ACCESSIBILITY RECOMMENDATIONS – CENTRAL PLAYGROUND ON MAIN ROAD

DARASHAKRAN CAMP - ERBIL- DECEMBER 2014

TO PROMOTE INCLUSION OF PERSONS WITH DISABILITIES, INJURIES AND OTHER VULNERABILITIES

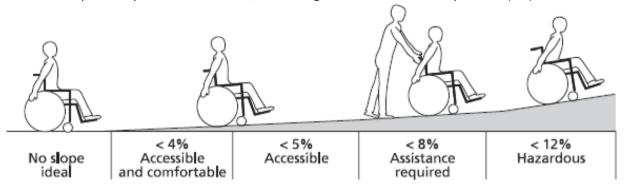
- Ensure all information is disseminated using appropriate and various communication means to consider people with visual, hearing, intellectual and mental impairments. (e.g. Large print, using loudspeakers / radio announcements, using simple, language, sketches and diagrams etc).
- Information should be communicated ideally 24 point size Arial font, black on yellow paper provides good contrast.
- Good lighting along the CFS, especially for night time.
- Grab rails to accompany any ramps as seen below

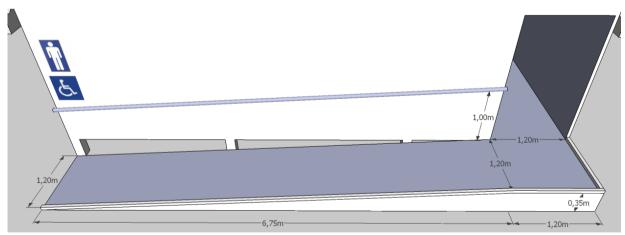
• A ramp is always better than stairs, the ideal gradient should be five per cent (5%) and it should have a smooth and non-slip surface.

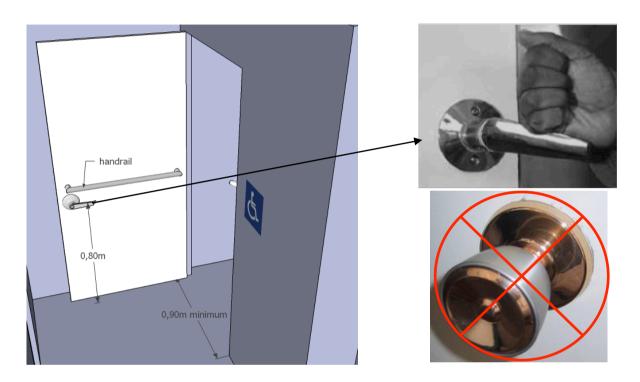
• There should be a level platform space at the end of the ramp to allow the person to stop and turn.
